## ADDENDUM #1

Reference: Mammoth Creek Fish Hatchery  
Filtration Building  
DFCM Project No. 04007520

**UTAH DIVISION OF WILDLIFE RESOURCES  
MAMMOTH CREEK HATCHERY  
INFLOW FILTRATION - 2005**

**ADDENDUM #1  
October 11, 2005**

**Sketch 1 – Location of outlet box in relation to drum filters.**

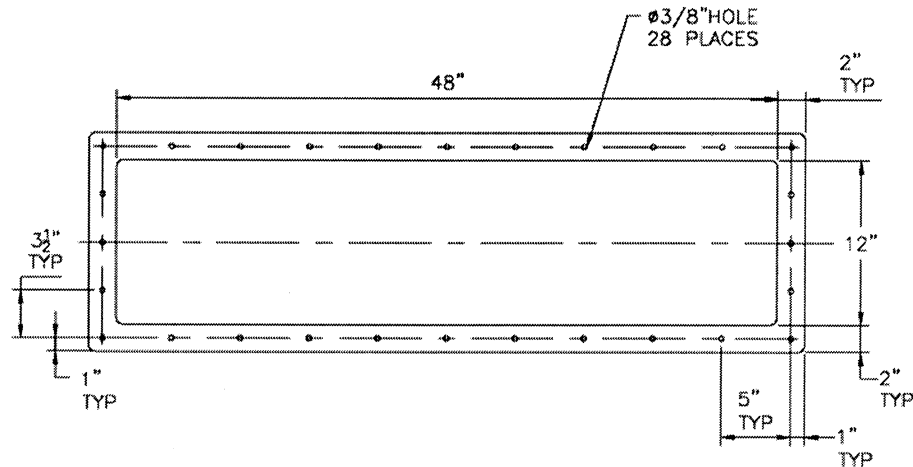
1. The outlet box is constructed of 1/8" aluminum. As long as the slab in the area of the drum filters and outlet box is flat, all three pieces should mate without shimming or excessive use of sealant. In order to provide some flexibility in the fit, the outlet box openings to receive flow from the drum filters are to be field located.
2. Position the outlet box between the two drum filters as per the sketch below.

3. Cut openings in the outlet box walls to match the inside surfaces of the transition pieces from both drum filters. Drill bolt holes through the outlet box wall and the FRP as shown in Sketch 2.
